STAFF REPORT
COMMUNITY DEVELOPMENT DEPARTMENT

DATE: 10/21/2025
TO: City Council
FROM: Sonya Allen, Associate Planner
208-884-5533
sallen@meridiancity.org
SUBJECT: FP-2025-0009
District Ten Mile Subdivision No. 1

Final plat consisting of 17 buildable lots on 34.04 acres of land in the C-G zoning district for the first phase of District Ten Mile Subdivision.

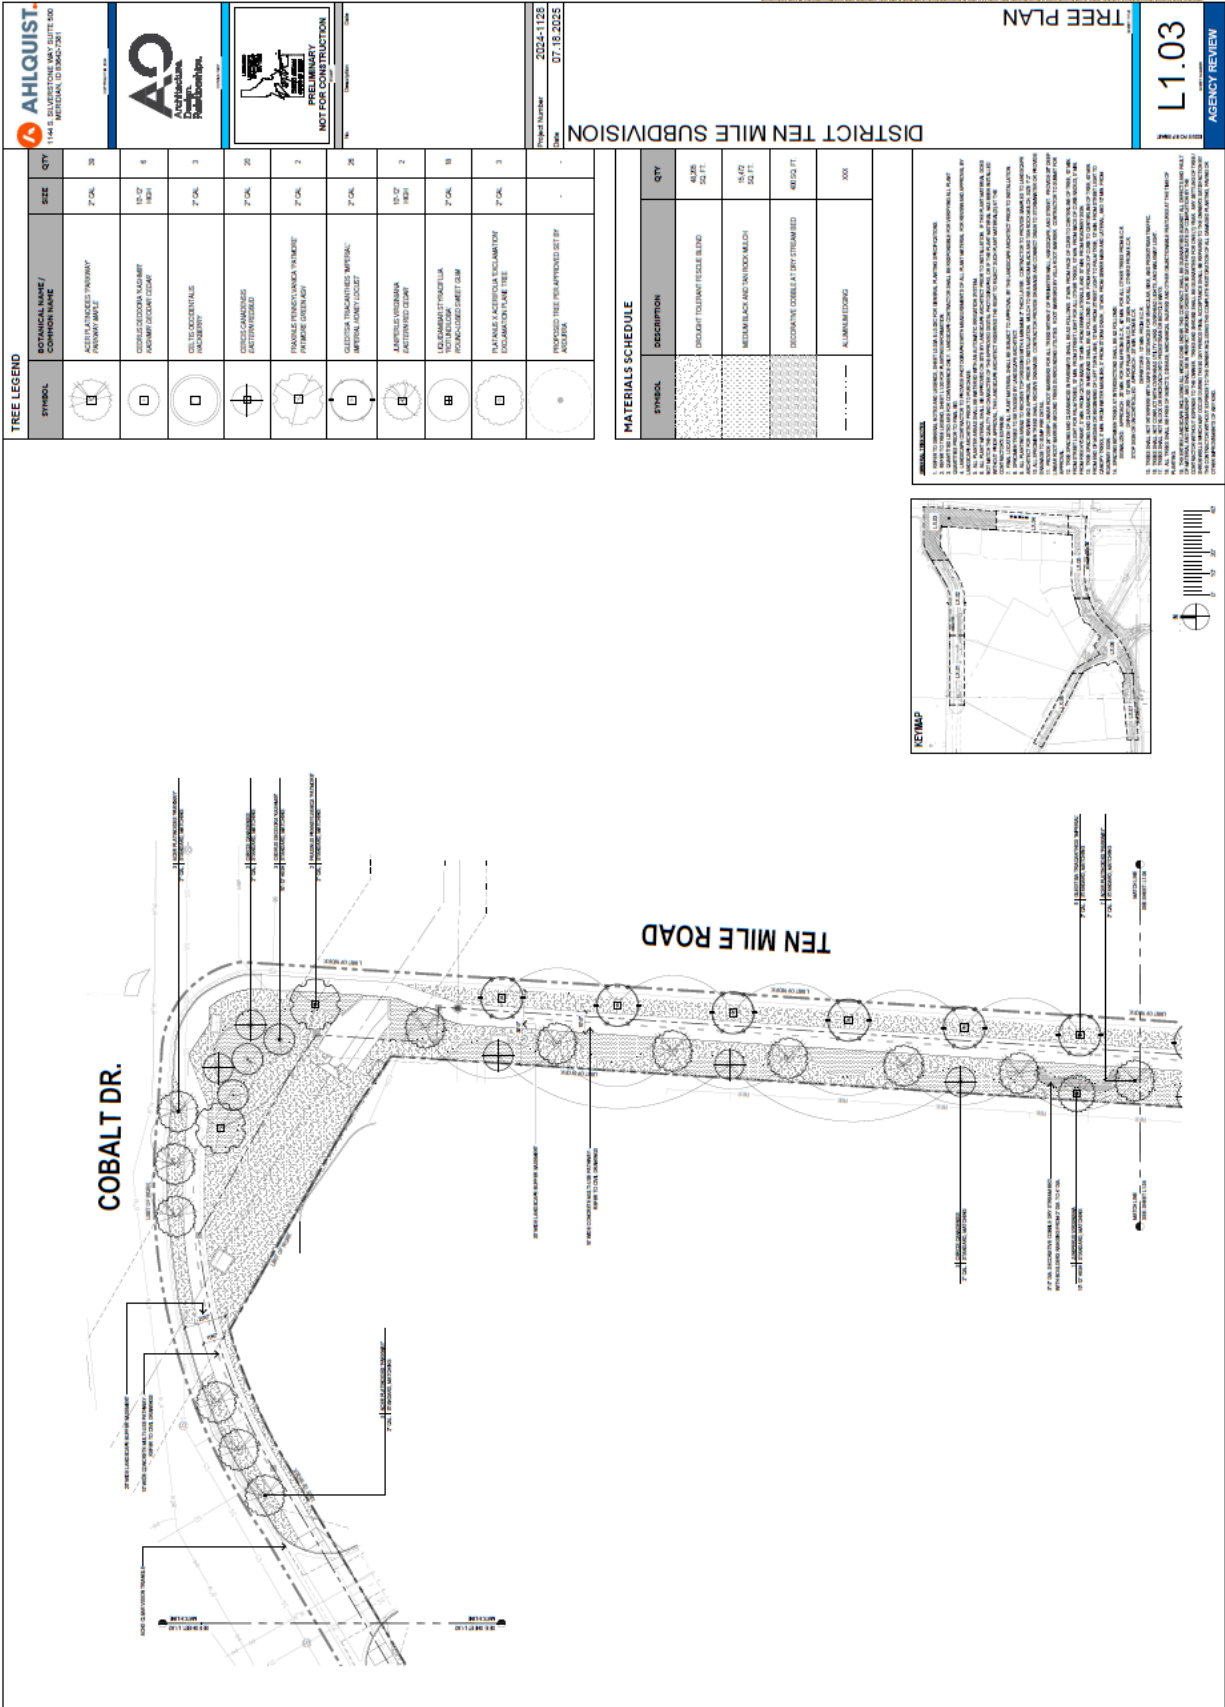
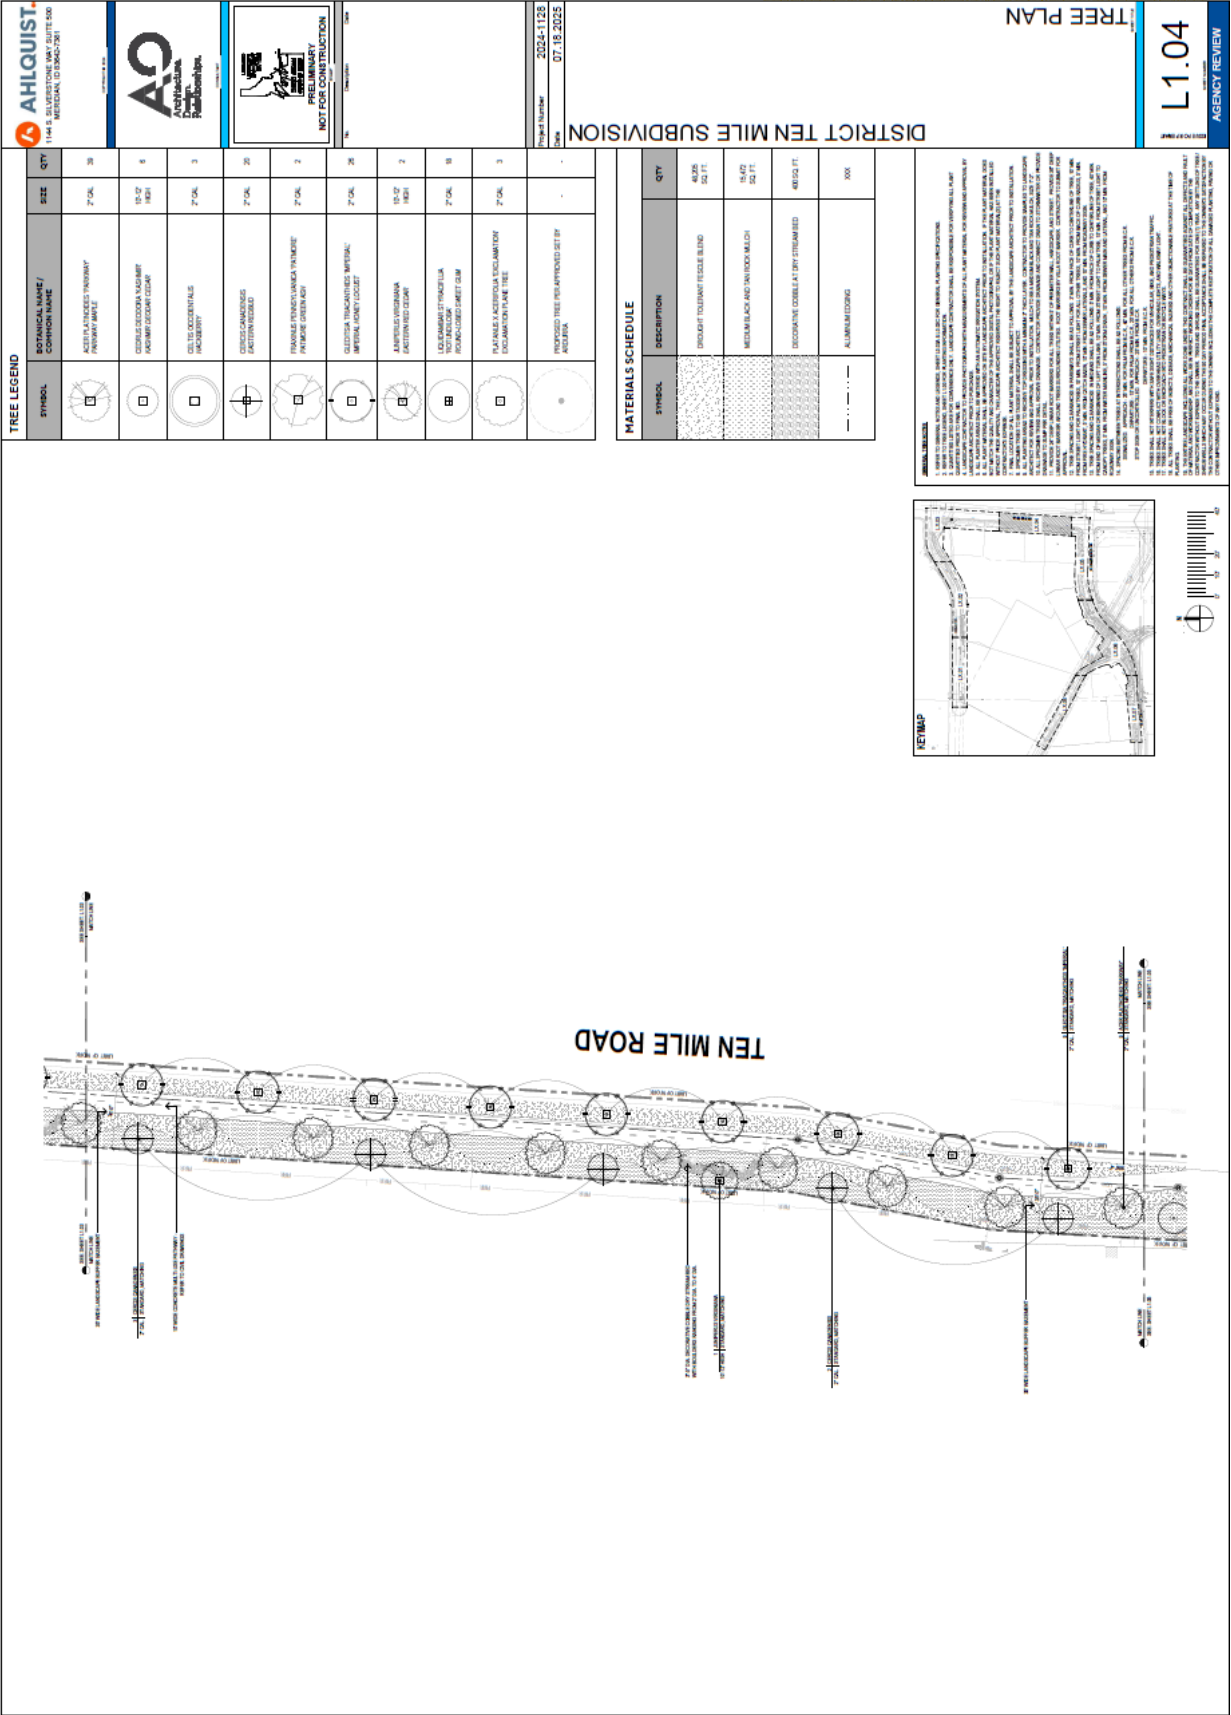
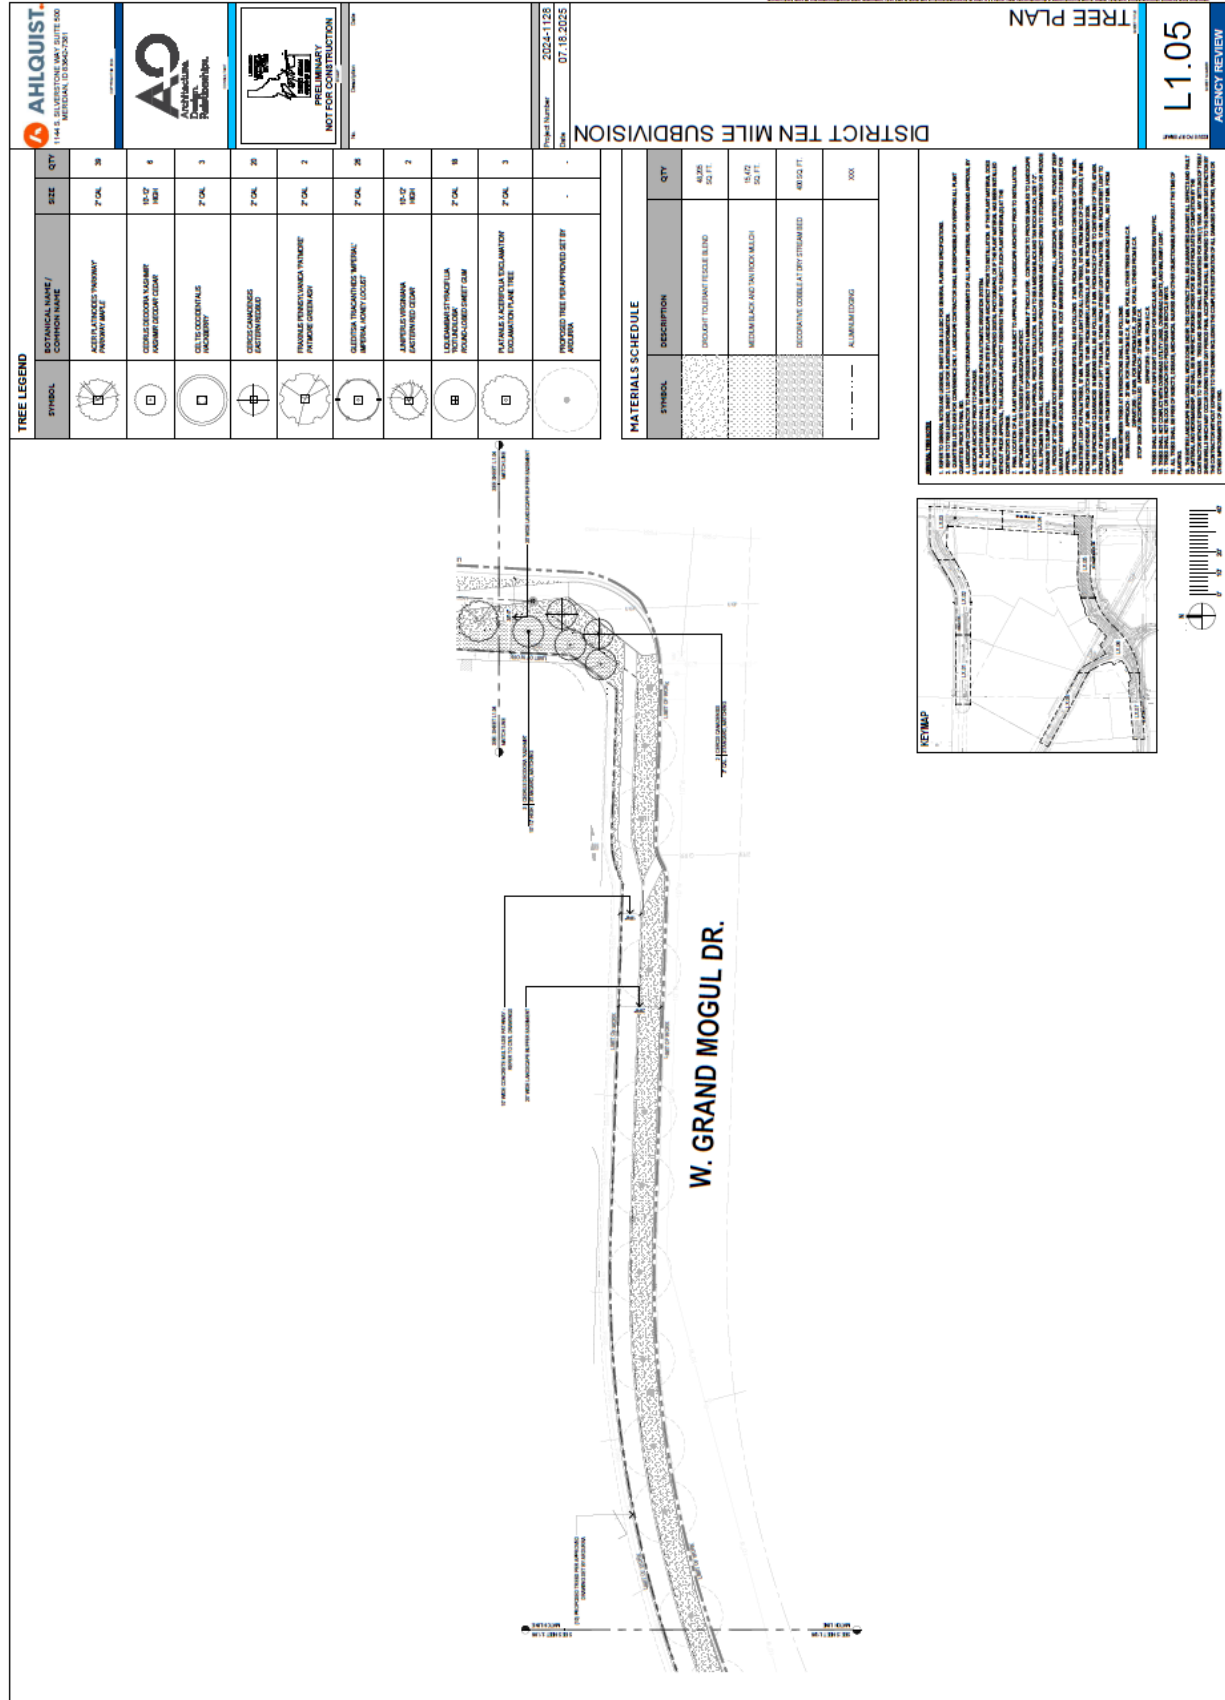
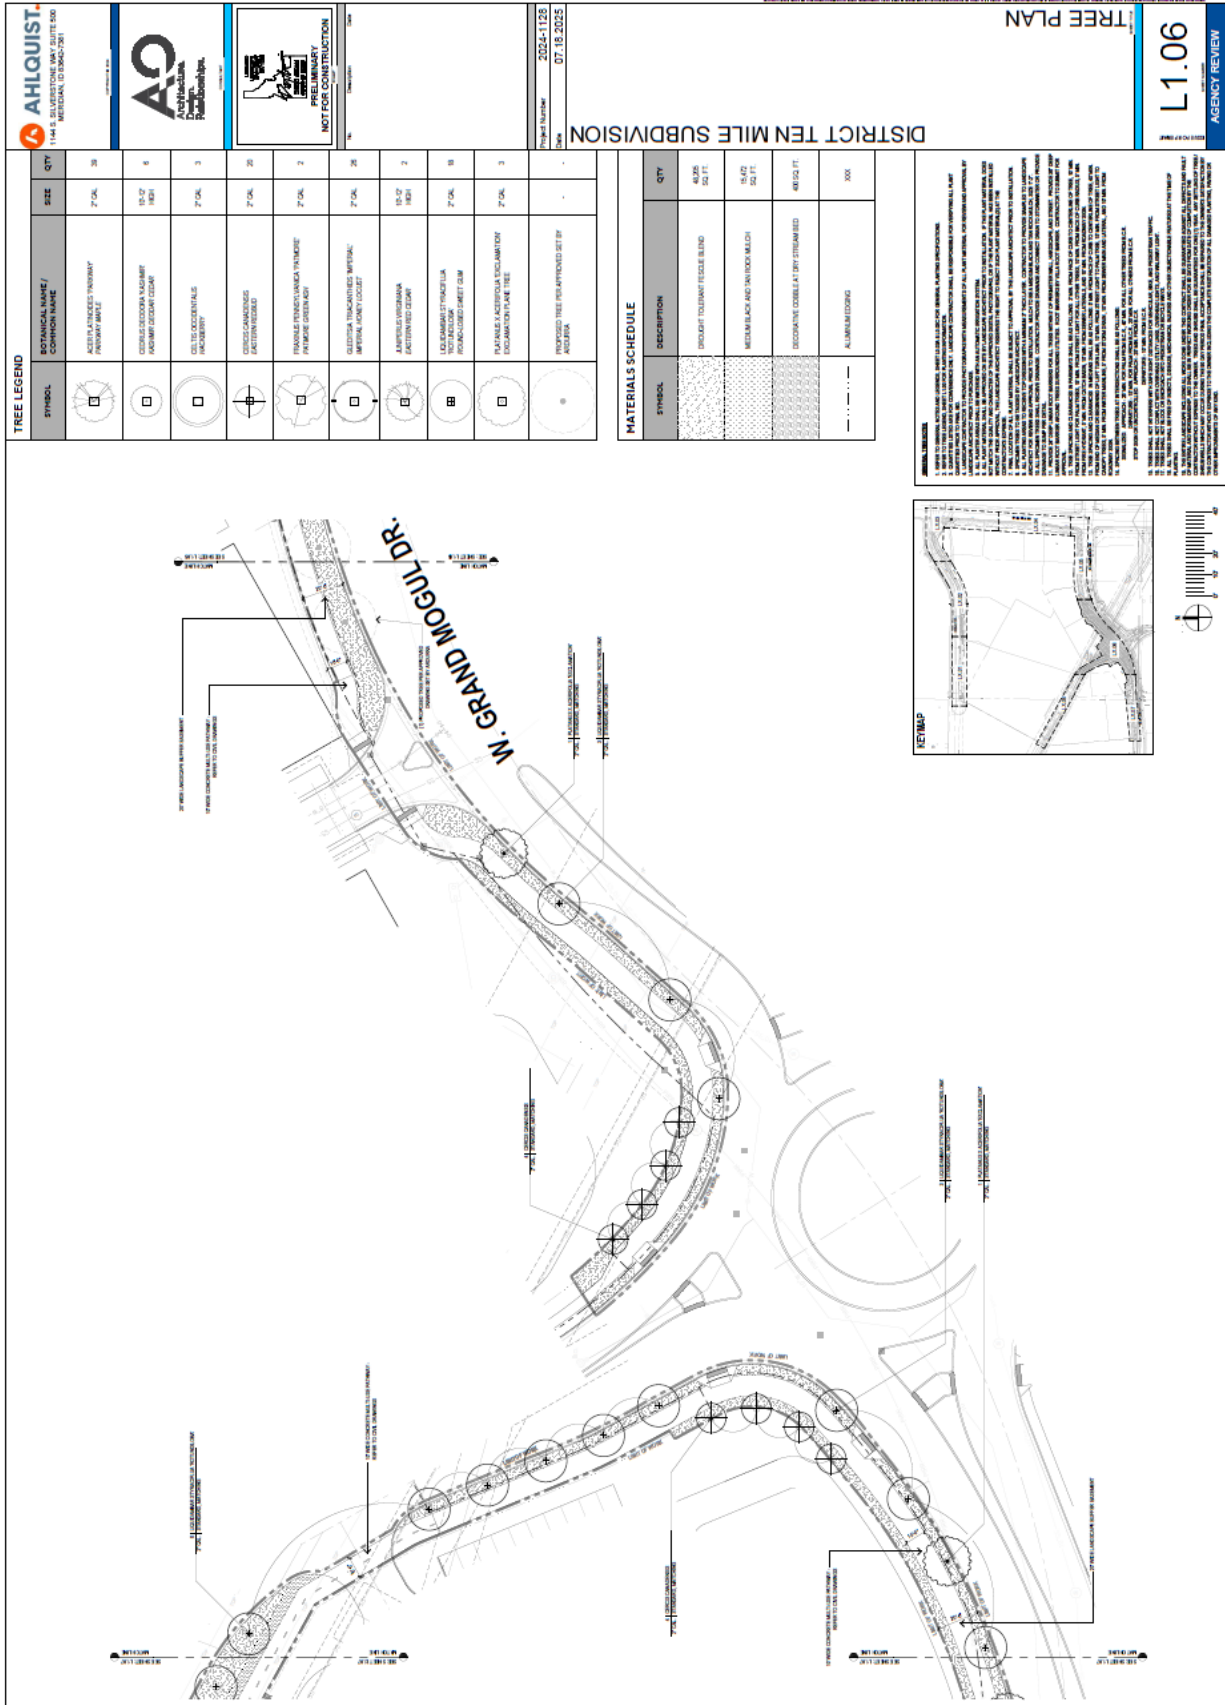
- a. Depict 10-foot-wide detached sidewalks/pathways in the street buffers along N. Ten Mile Rd. and W. Grand Mogul in the areas where 6-foot-wide walkways are currently depicted near the intersections of Grand Mogul/Ten Mile and Cobalt/Ten Mile unless a physical barrier exists that prevents compliance.

- b. Depict landscaping within the street buffer along W. Grand Mogul Dr. in accord with the standards listed in UDC 11-3B-7C.3 (i.e. depict a variety of shrubs and vegetative groundcover along with the 37 trees that elicit design principles including rhythm, repetition, balance and focal elements). Also revise the Project Calculations table on Sheet L1.00 to reflect a total of 37 street trees are proposed in the buffer.

- c. Depict landscaping along the multi-use pathway adjacent to the Purdam Drain in accord with the standards listed in UDC 11-3B- 12C (i.e. 5-foot-wide landscape strips are required along each side of the pathway planted with a mix of trees, shrubs, lawn, and/or other vegetative groundcover – a minimum of one tree per 100 linear feet of pathway is required – include calculations in the Project Calculations table that demonstrate compliance).

- d. Widen the 5' wide parkways depicted west of first driveway off Grand Mogul to 8' consistent with Street Sections B & C in the TMISAP.
- 6. A Certificate of Zoning Compliance application shall be submitted and approved for all development on the site prior to submitting any associated building permit applications.
